ADDENDUM

JLG 24146-5 Dunn County Courthouse Renovation

Issued: November 4, 2025

ADDENDUM #: 01

2 FIRST FLOOR PLAN - AREA B - MECHANICAL PIPING - BASE BID
1/8" = 1'-0"

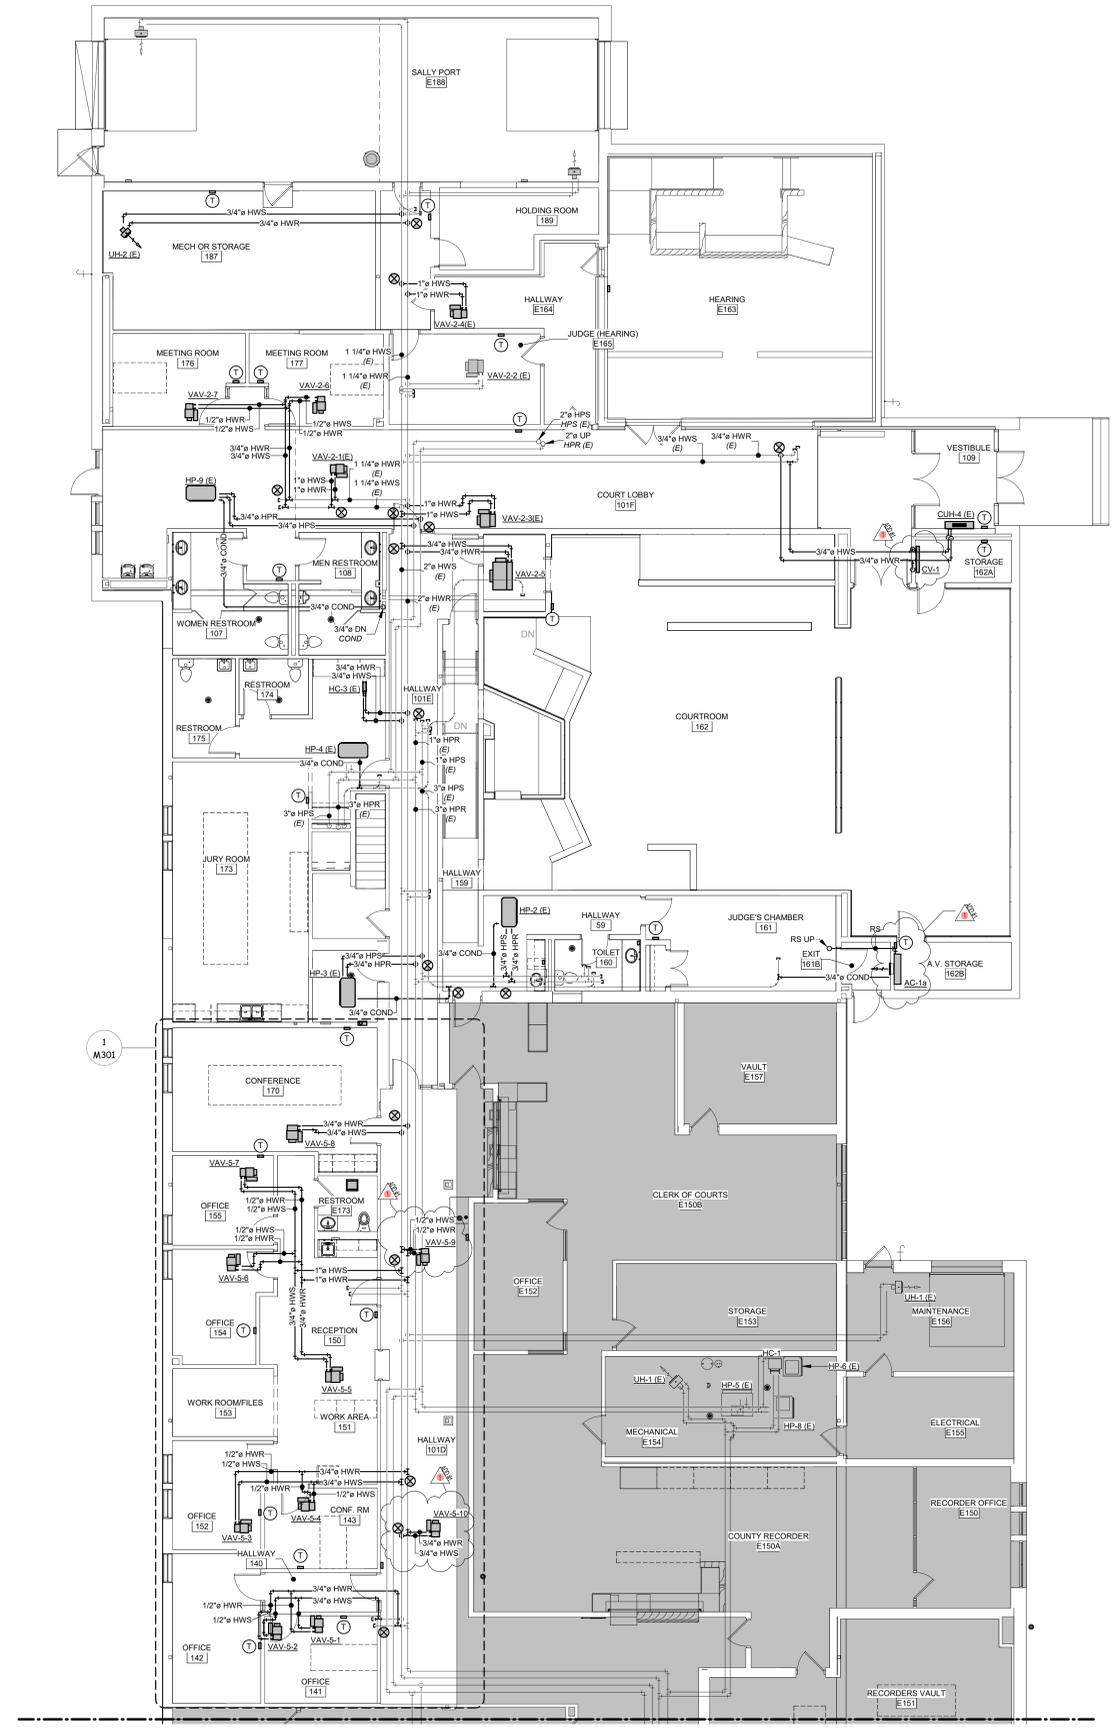
5. M301 – FIRST FLOOR PLAN MECH PIPE
 - Drawing 1/M301:
 - Provide electric duct heaters EDH 5-9 and EDH 5-10
 - Drawing 2/M301:
 - Provide CV-1 in lieu of CUH-5 in Storage 162A

- Provide wall-mounted AC indoor unit in lieu of ceiling mounted AC units in AV Storage 162B.
 - Provide condensate piping for new and relocated heat pumps around the courtroom.

- Provide the additional variable air volume units VAV-5-9 and VAV-5-10.
6. M302 – HYDRONIC SYSTEM SCHEMATIC
 - General Page information:
 - Page is numbered to M302.

1 M302 HYDRONIC SYSTEM SCHEMATIC

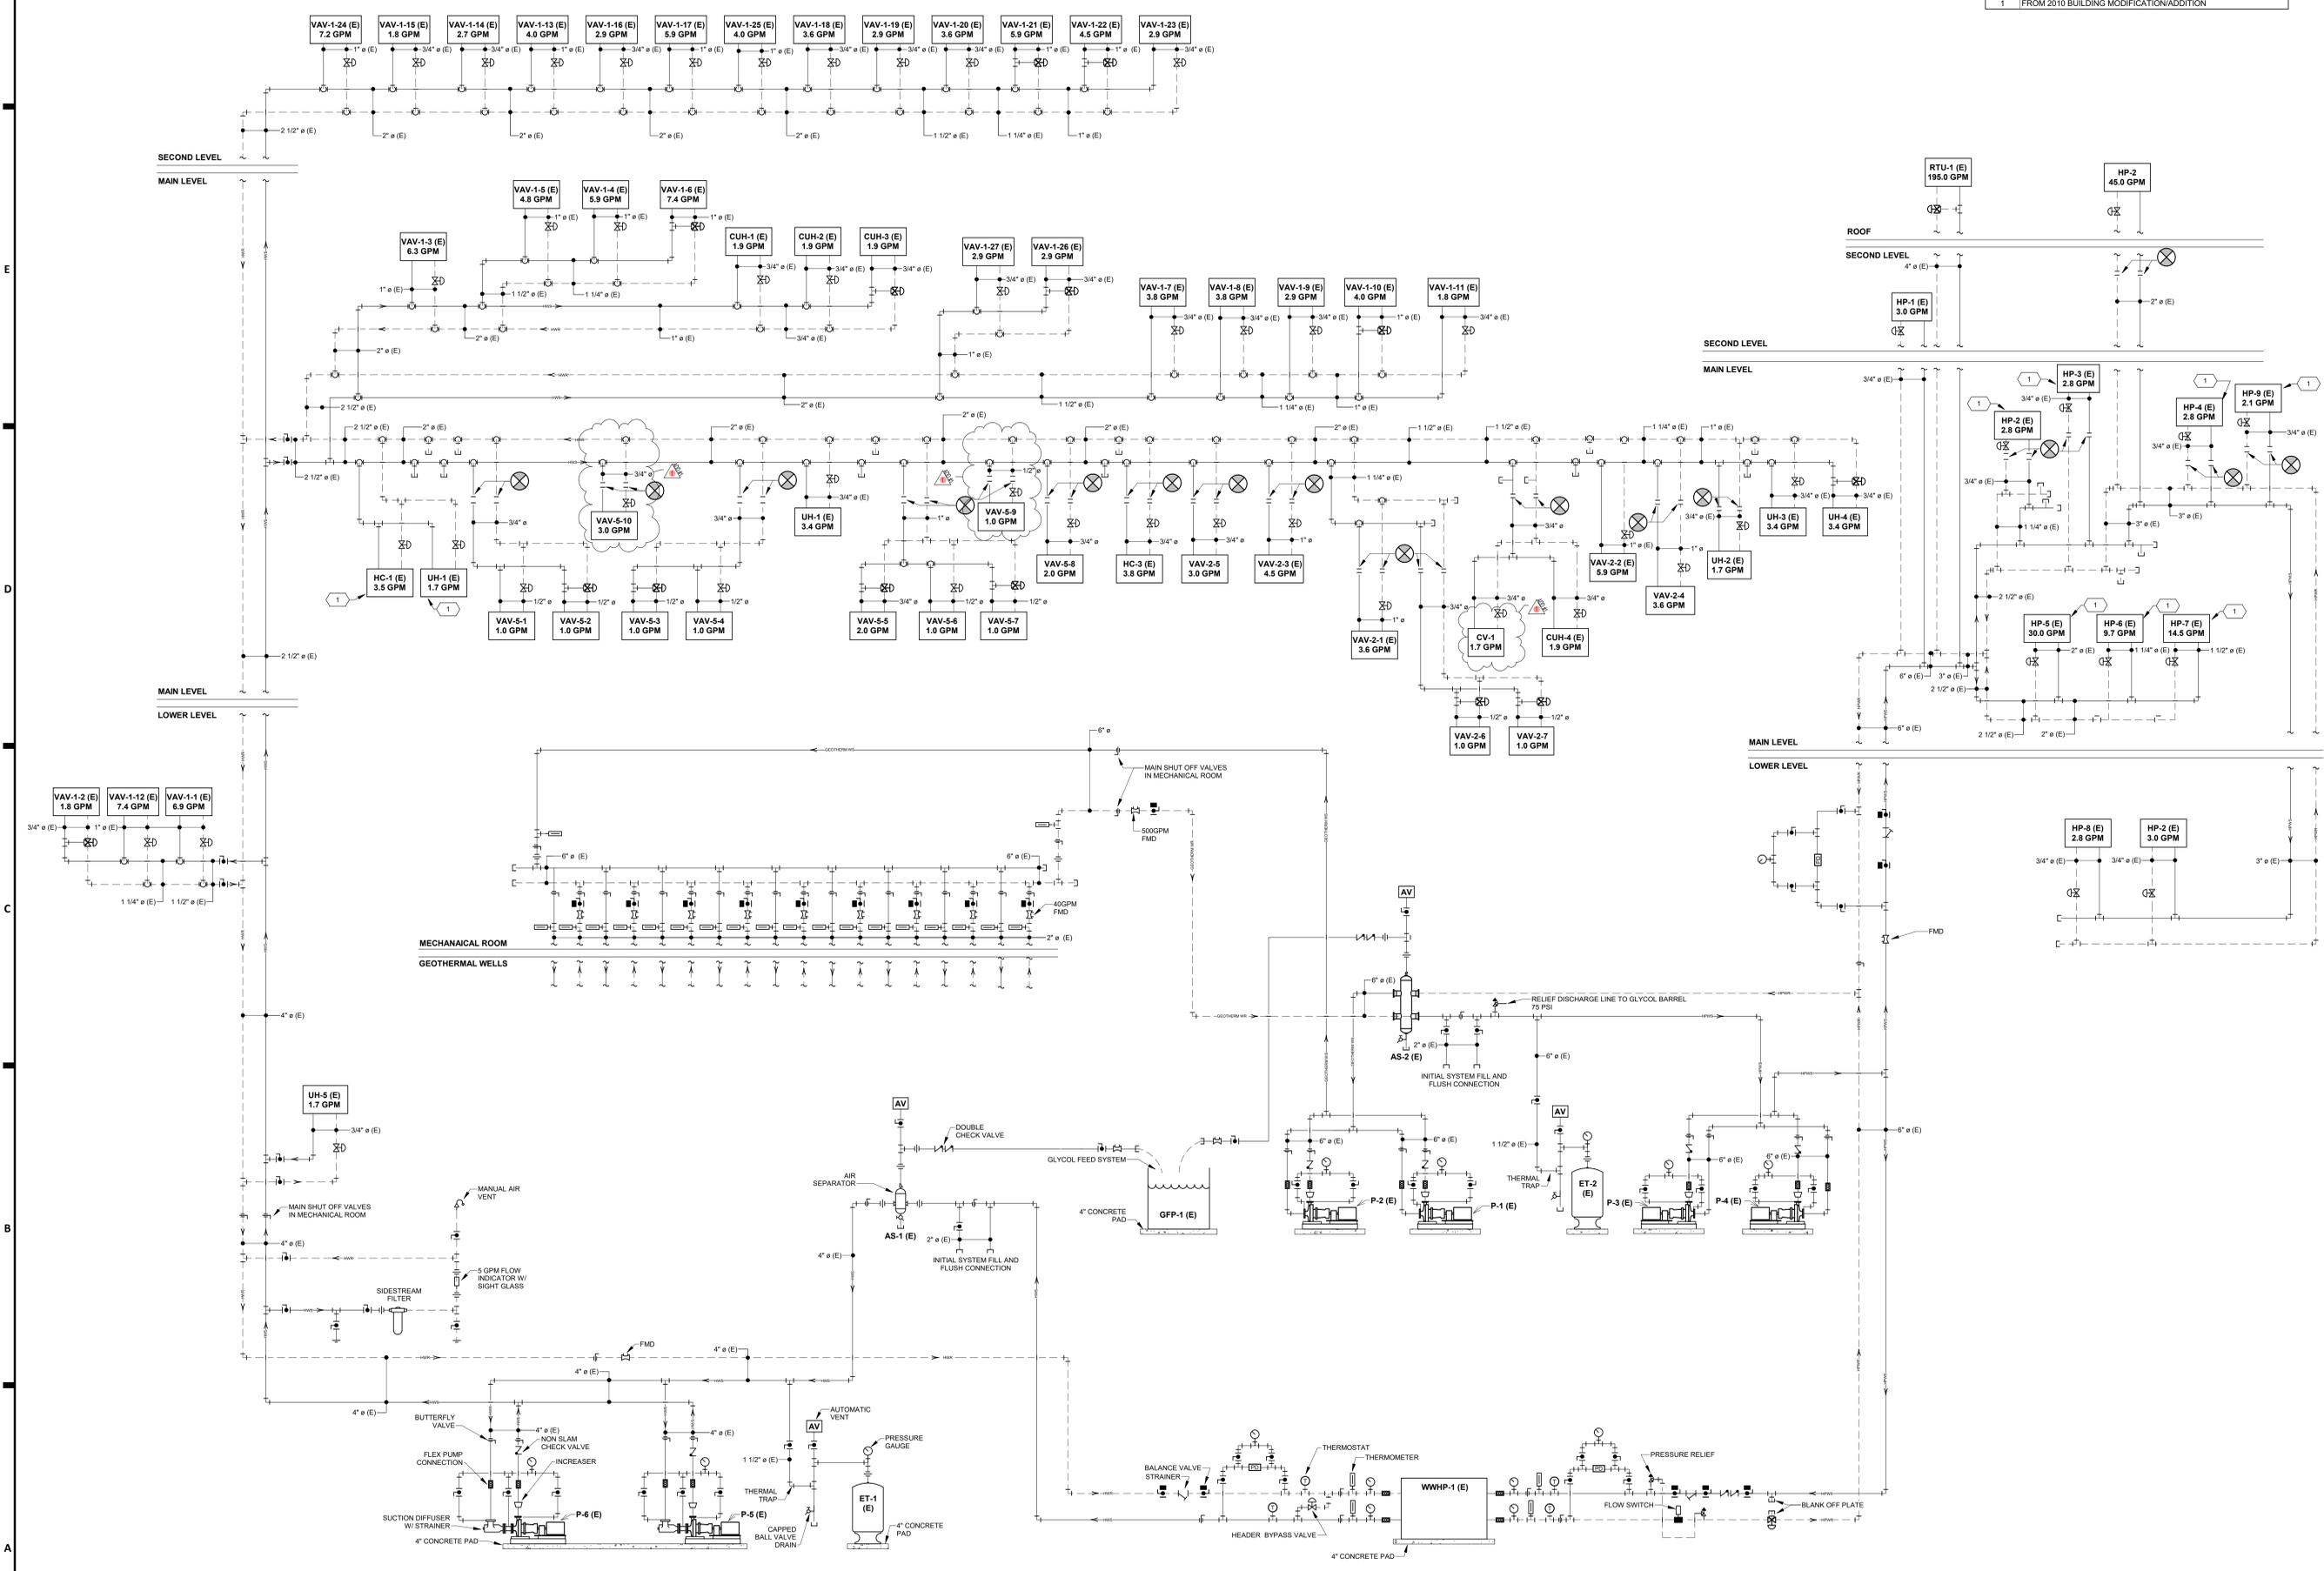
- Drawing 1/M302:
 - Elements CV-1, VAV-5-9, and VAV-5-10 are added to the system schematic.
7. M401 – FIRST FLOOR PLAN HVAC
 - Keynotes for the Page:
 - Replace Keynote 1 with: 6" UP TO GOOSENECK ON ROOF.

2 FIRST FLOOR PLAN - AREA B - HVAC - BASE BID
1/8" = 1'-0"

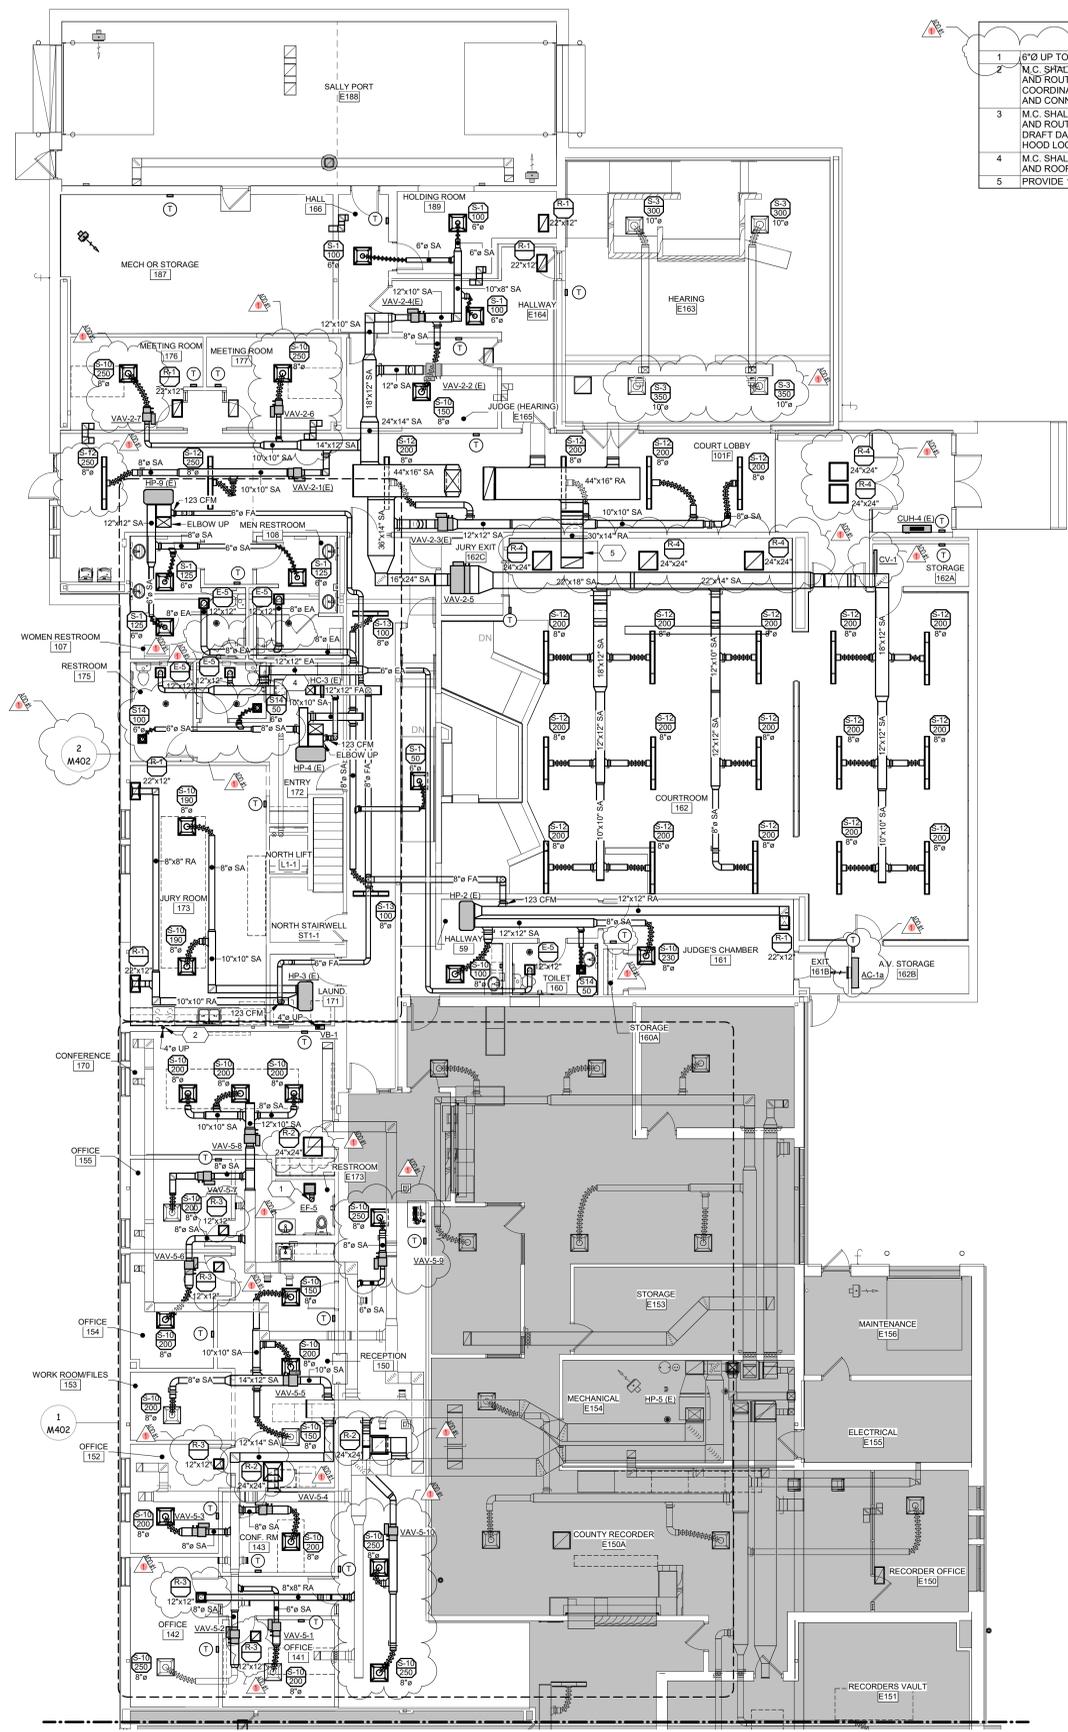
- Drawing 2/M401:
 - Adjusted airflows for rooms: 150, 176, 177, and E163
 - Elements CV-1, AC-1a, VAV-5-10 and VAV-5-9 are shown.
 - Provide additional diffuser for VAV-2-1(E) in Court Lobby 101F.

- Added return air terminals to rooms: 141, 142, 143, 152, 150, 154, 155, and 170.
 - Reception corridor (room 150) gets supplied with 750 CFM.
 - Added an area for a callout view to drawing 2/M402.

- Removed the additional exhaust terminal in rooms 107 and 108.
 - Removed supply terminal in room 172.
 - Adjusted supply terminal in room 175 to 100 CFM.

2 M402 FIRST FLOOR PLAN - AREA B - BASE BID DETAIL
1/4" = 1'-0"

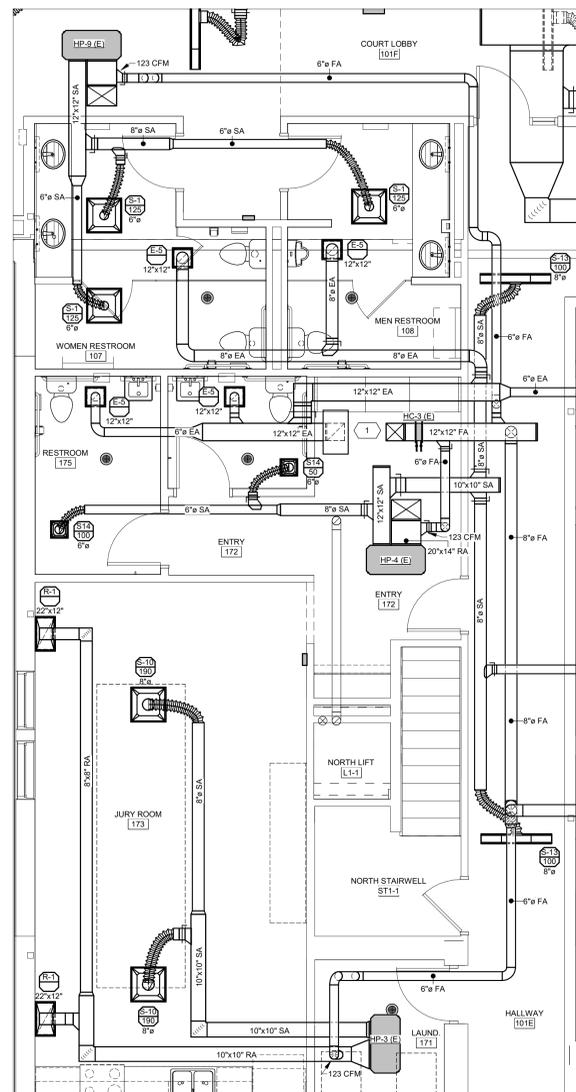
8. M402 – FIRST FLOOR PLAN HVAC
 - Alternate Bid 3 Schedule: 238000 – ELECTRIC DUCT HEATER SCHEDULE:
 - Modify as shown on attached sheet.
 - 2/M402:
 - Drawing 2/M402: Added callout view for the area in drawing 2/M401.

1 M402 FIRST FLOOR PLAN - AREA B - HVAC - ALTERNATE BID 3
1/4" = 1'-0"

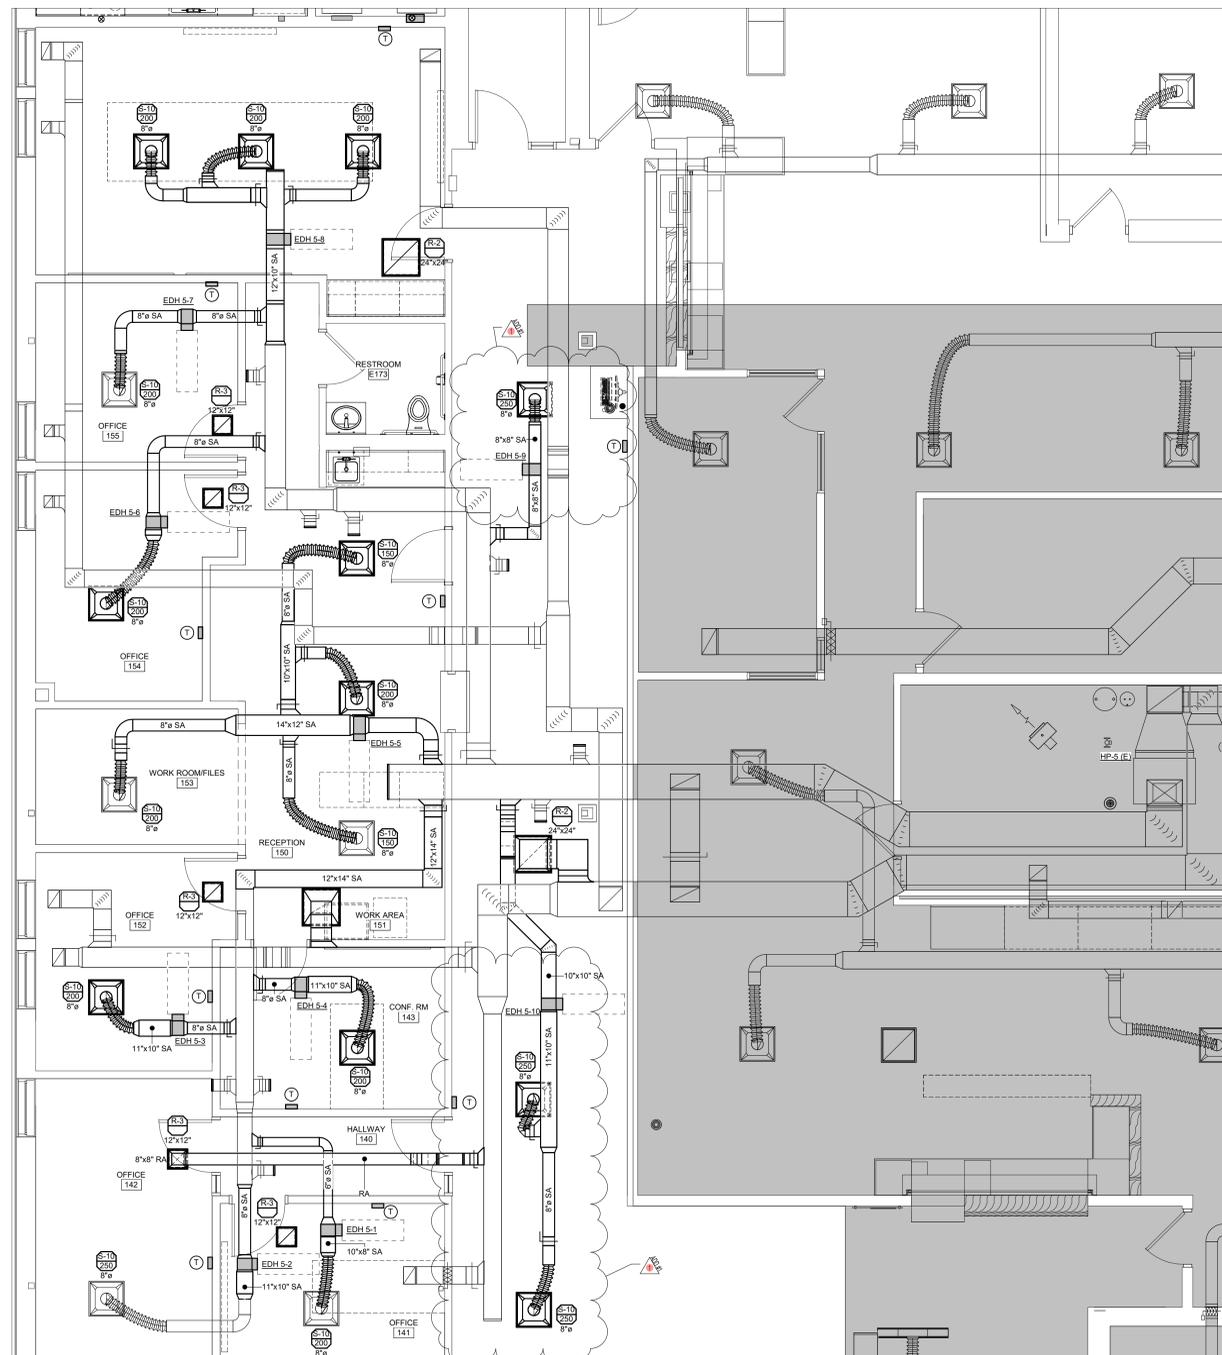
- Drawing 1/M402:
 - Provide return grilles as shown.
 - Provide supply grilles in corridor.
 - Provide duct heaters EDH 5-9 and EDH 5-10 for corridor.
9. M403 – SECOND FLOOR PLAN HVAC

1
M403
SECOND FLOOR PLAN - AREA A - ALTERNATE BID 1
1/8" = 1'-0"

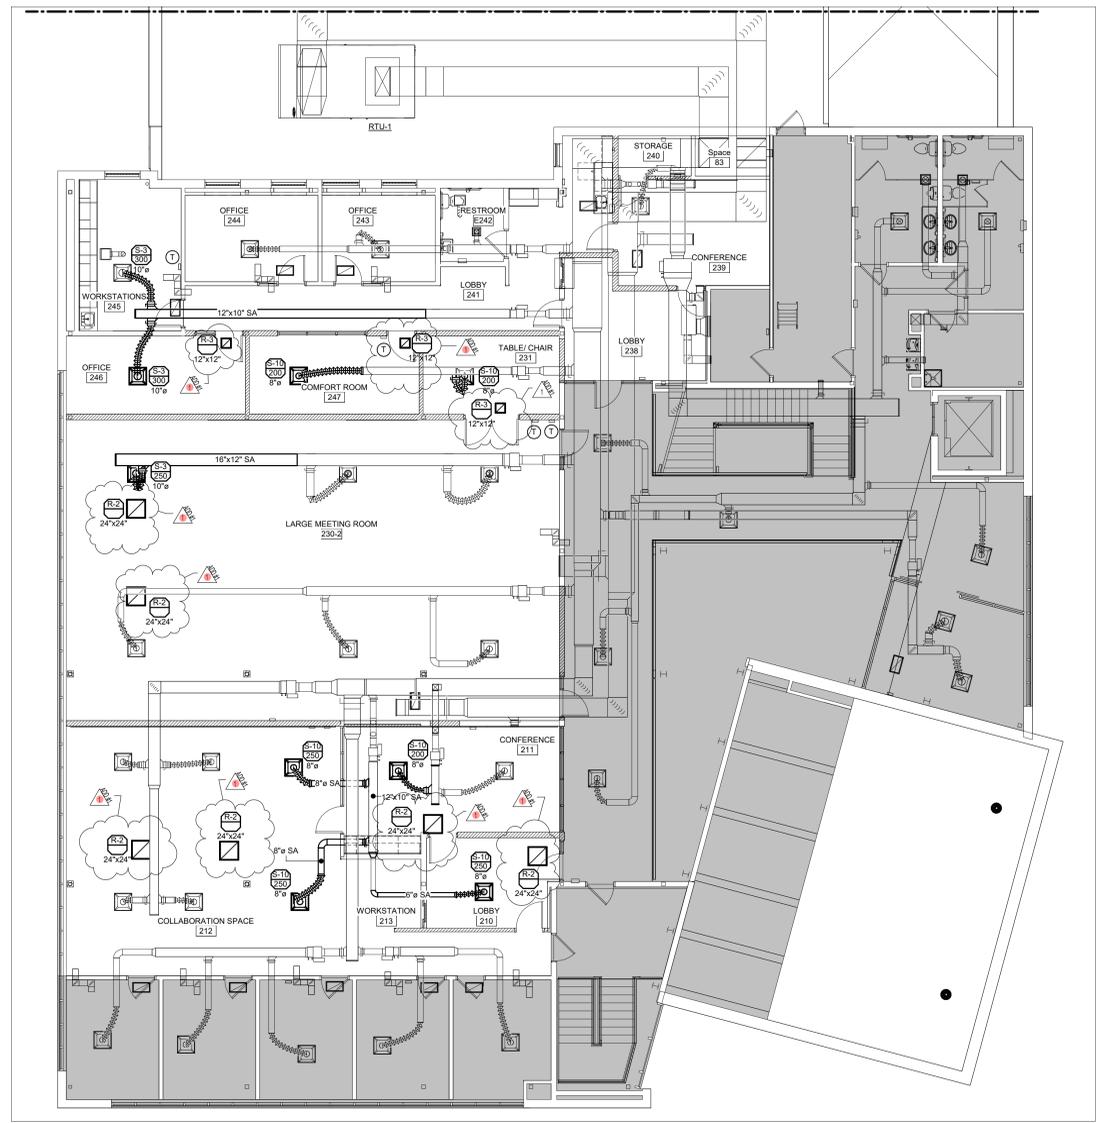
- Drawing 1/M403:
 - Clarification for airflows added to drawing.
 - Return air terminals are shown for the following rooms: 230-2, 246, 247, 231, 212, 211, and 213.
